City of Detroit
Inter-Departmental Communication

RE: Petition No.1007
Requested Encroachment Into Temple For Parking Lane, Creation Of A
Pedestrian Easement, And Construction Of A Drop Off Lane, In The Block Bound
By Trumbull, Temple, Brooklyn, And Perry

PROVISIONS FOR ENCROACHMENT For Petition 1007

JOB NO. 01-01
 DRWG. NO. X 1007

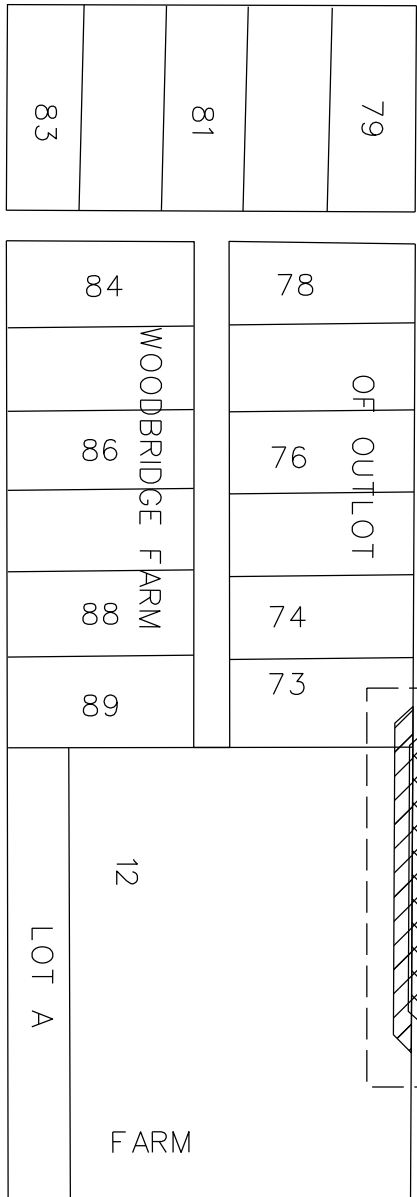
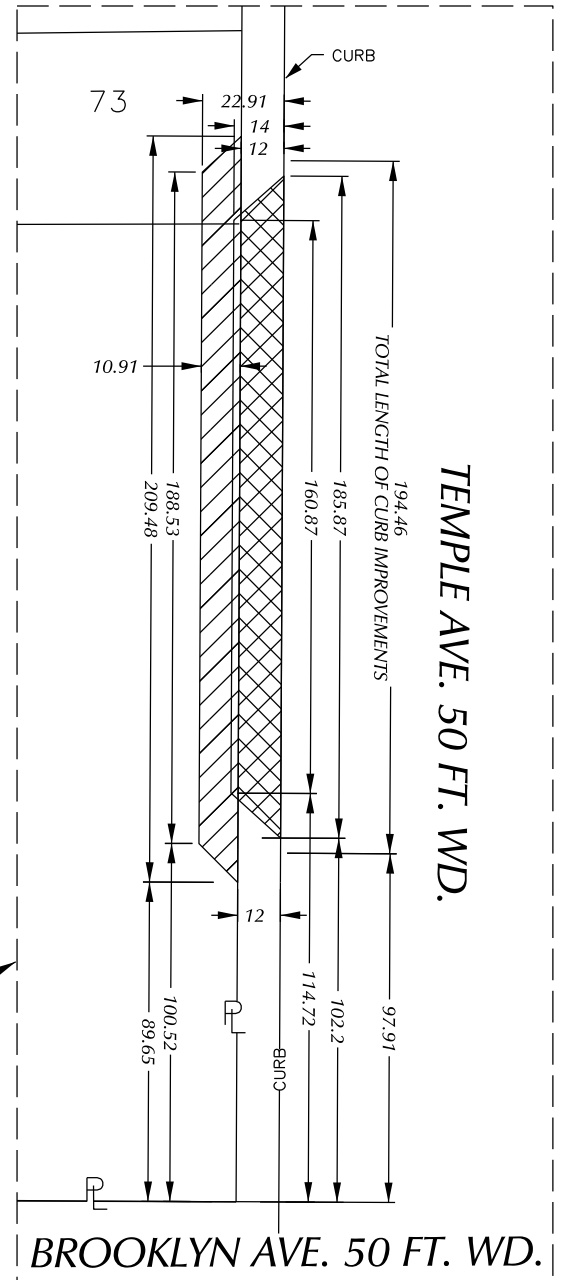
- Our records indicate there are a water main and sewers in Temple in the requested area of encroachment. DWSD has no objections to the requested encroachments provided that the attached Provisions for Encroachment are strictly followed.

2. DWSD requires a vertical clearance of 18 feet above grade for maintenance excess and repair.
3. All construction performed under this petition shall not be commenced until after five (5) days written notice to DWSD. Seventy-two (72) hours notice shall also be provided in accordance with P.A. 53 1974, as amended, utilizing the MISS DIG one call system.
